APCW 2006-9483-SPE-CDP-CU-SPP-SPR-MEL

3/23/2007

Re: ENV-2006-9485-MND  
901 S. Abbot Kinney Blvd.

Map 1

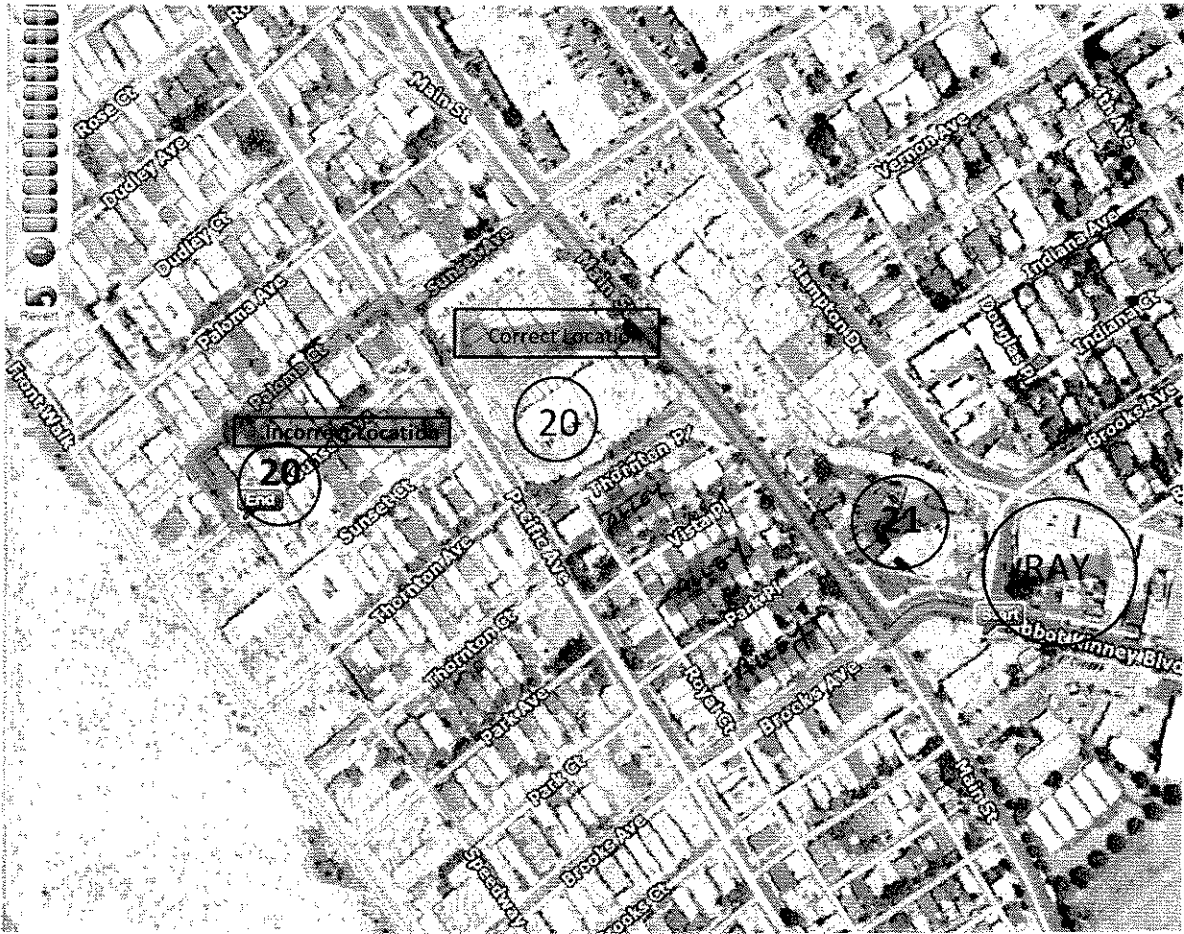
We are located 528 feet northwest of the proposed project in the area bound by Brooks Ave. (south), Thornton Place (north); and between Main (east) and Pacific (west). This 4.25 acre neighborhood is made up of narrow alleys and walk streets. Most maps do not indicate that there is no vehicle access in this area of walk streets except for the narrow alleys that serve this residential area. (Map 1)

Currently under construction, this project consists of 35 condominiums and is not included as a Related Project under construction even though it is less than 100 feet northeast of the proposed Ray Hotel. This project was also NOT considered as part of the Traffic Study. (*Map 1*)
